DCR PHOENIX HOMES

SPRINGFIELD
STANDARD KITCHEN
MOUNTING HEIGHT - 84

DV2- Lot 12

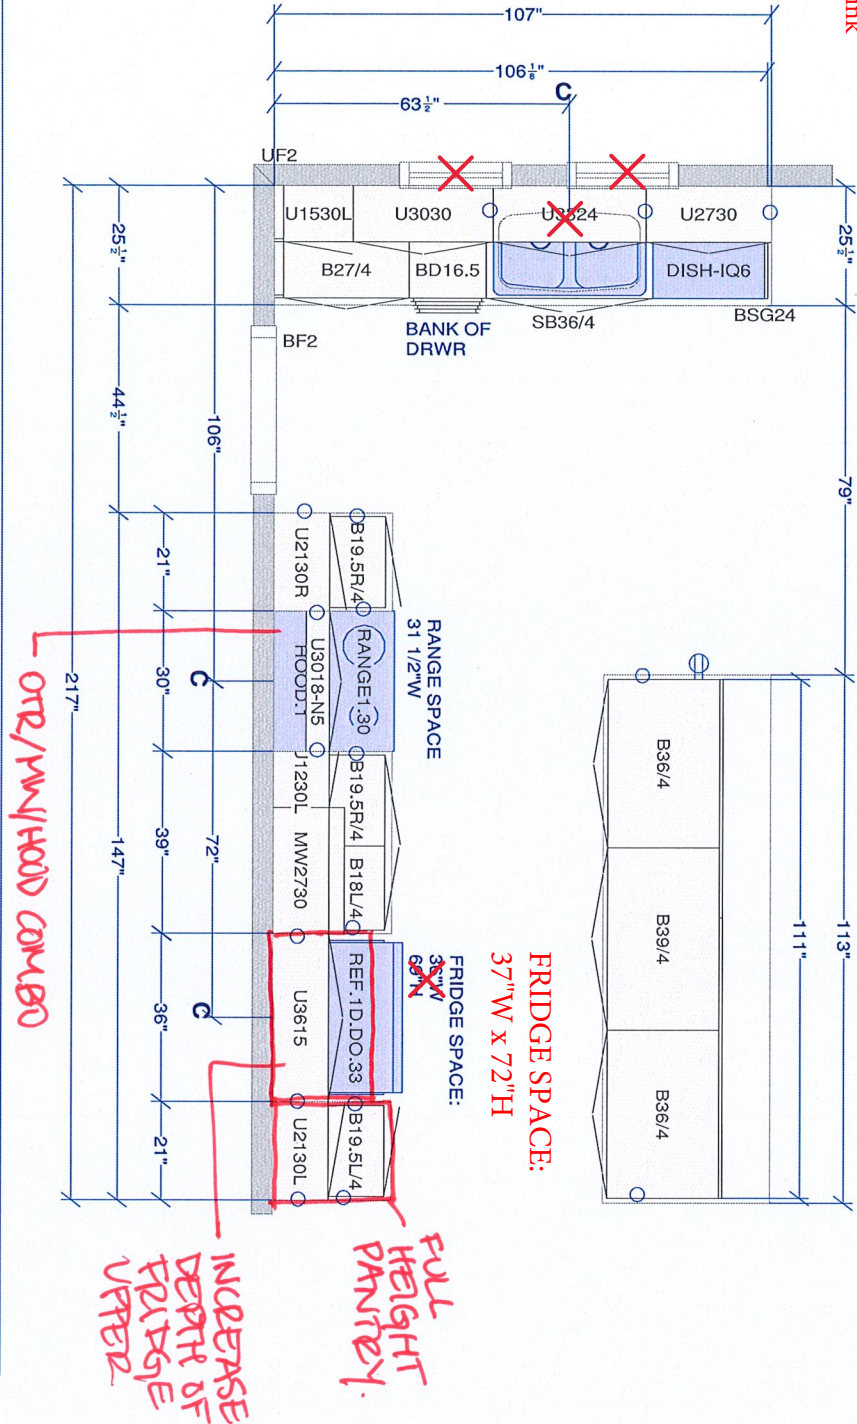
Delete (2) standard windows in kitchen S/I (1) 40x40 operable casement window above sink

KITCHEN TOP VIEW
DCR - SPRINGFIELD STANDARD KITCHEN

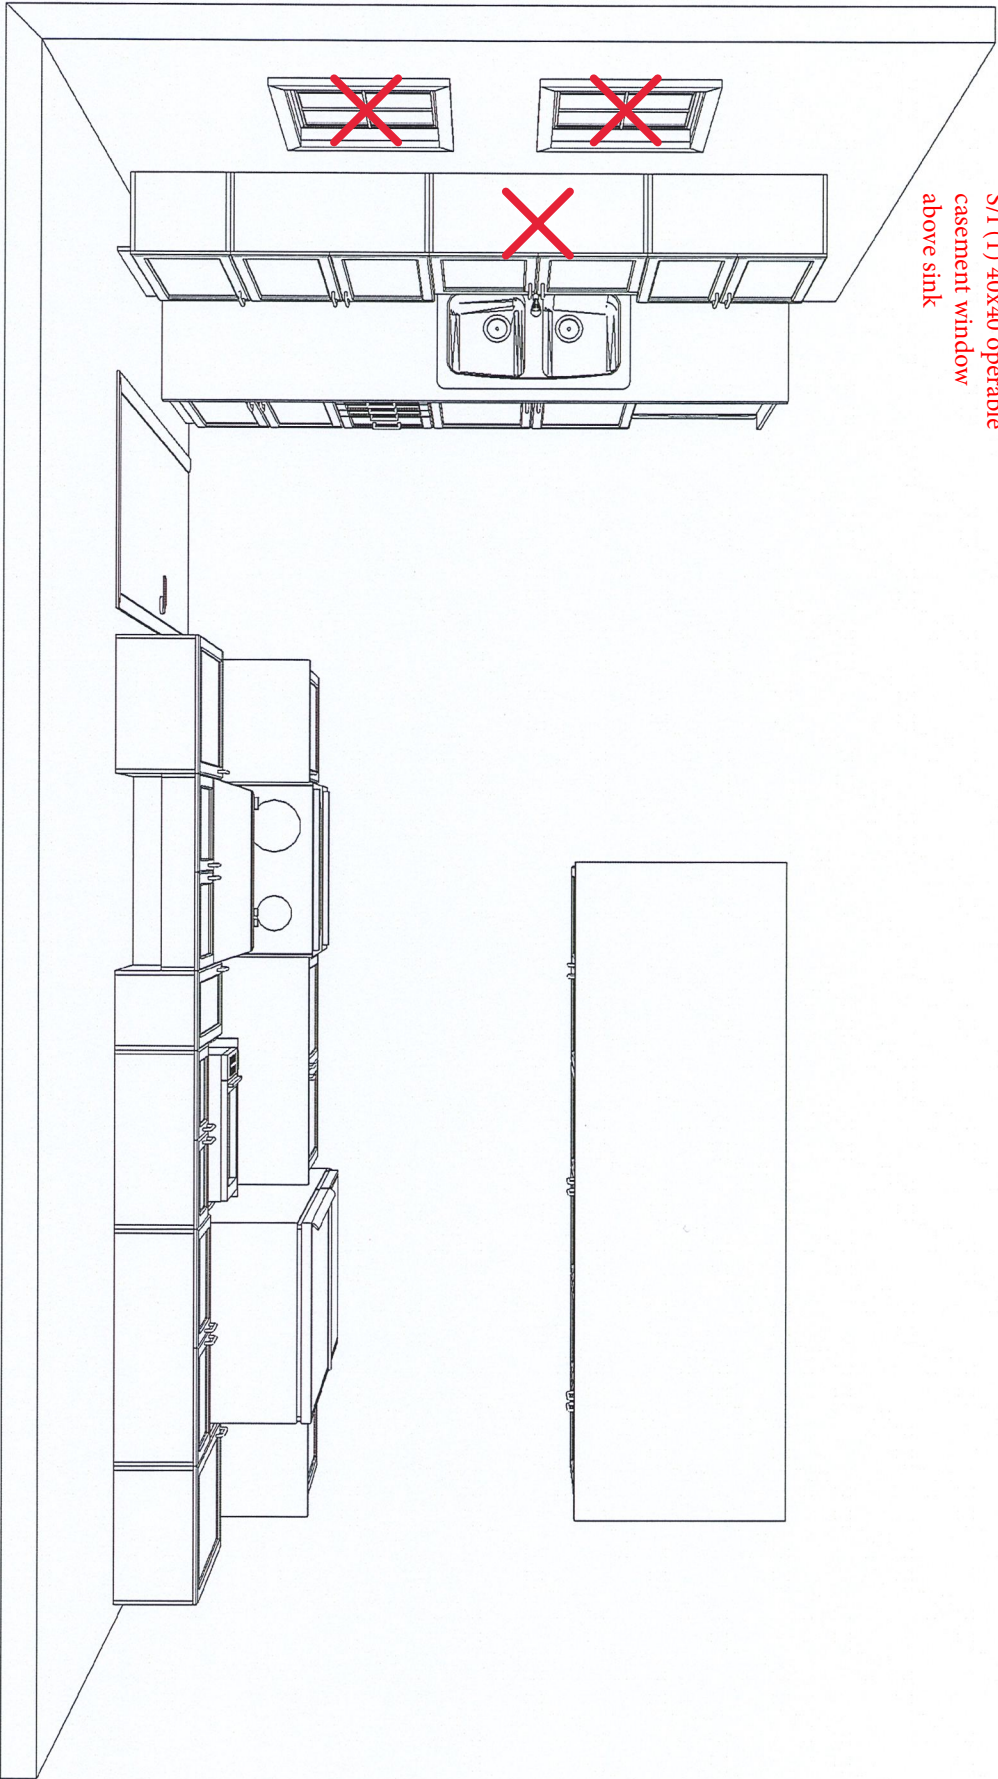
Delete (2) standard windows in kitchen
S/I (1) 40x40 operable casement window above sink

SINK WALL ELEVATION
DCR - SPRINGFIELD STANDARD KITCHEN

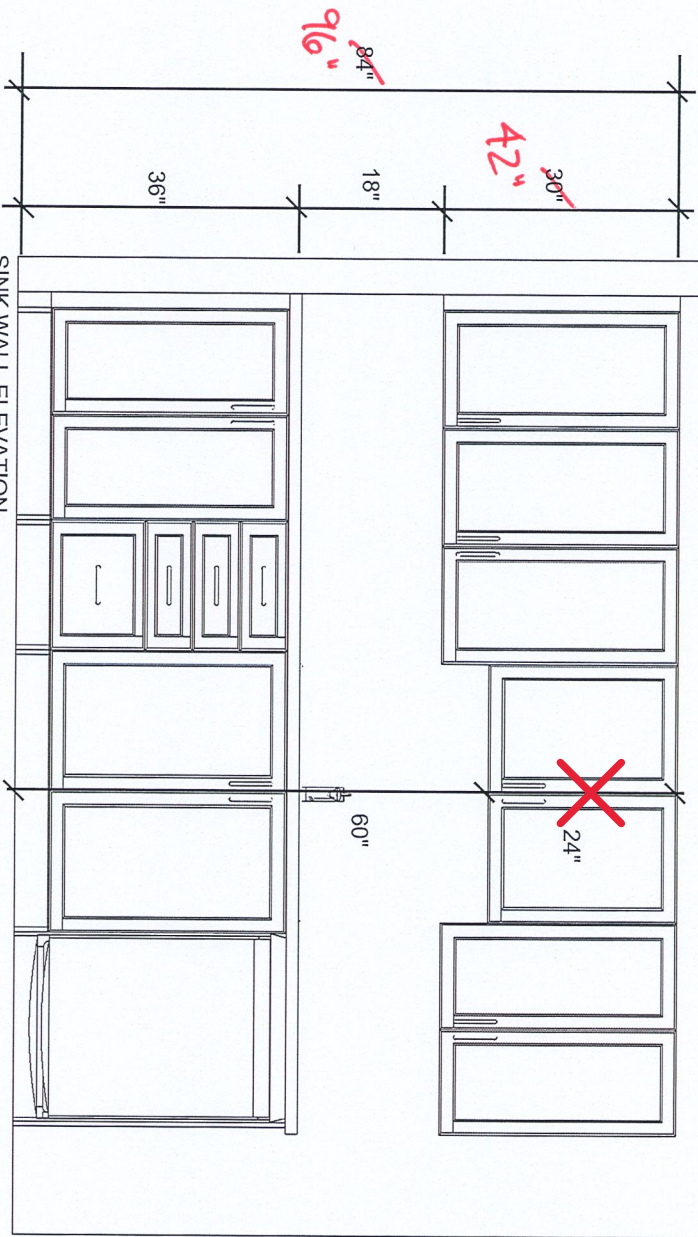
Delete (2) standard windows in kitchen
S/I (1) 40x40 operable casement window above sink

KITCHEN 3D-VIEW 1
DCR - SPRINGFIELD STANDARD KITCHEN

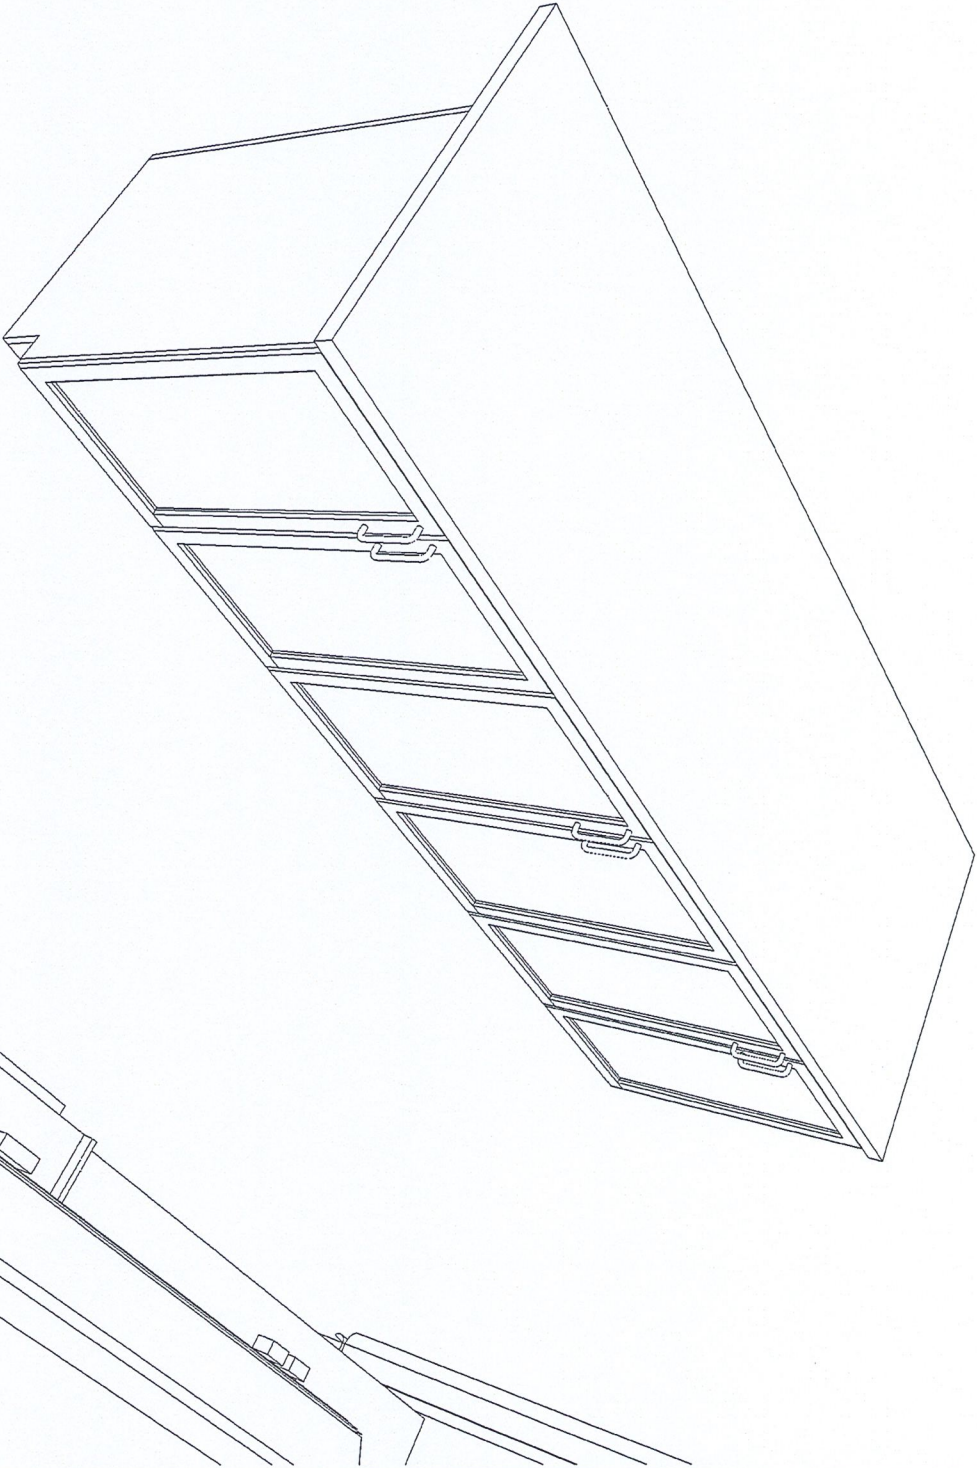
Delete (2) standard windows in kitchen S/I (1) 40x40 operable casement window above sink
